Bulletin Title		Group	NO
Service Action S10318: Decal Charge Lid, Certain Model Year 2021-2026 XC40, EX40, EC40 and C40 BEV vehicles		89	S10318
Issuer (Dept.)	Car Market	Issue Date	Status Date
Product, Safety and Compliance	United States and Canada	7/11/25	7/11/25
Revisions		Page	
		Page 1 of 3

**A. SERVICE ACTION S10318 DESCRIPTION**

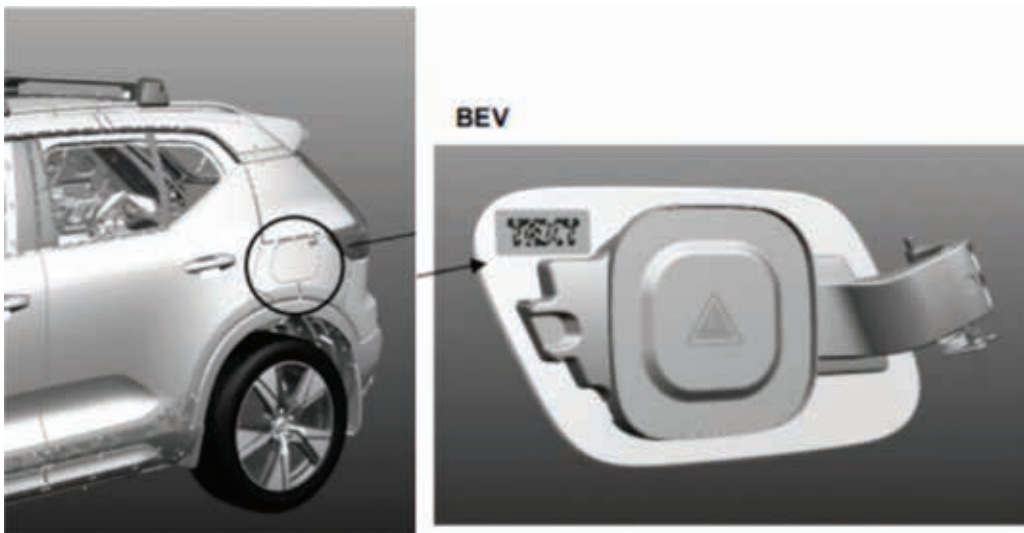
To avoid misuse, Volvo Cars will affix a NACS adapter warning label inside the charging lid.

**Important Note: Be sure to clean the area thoroughly with Isopropanol before applying the decal.**
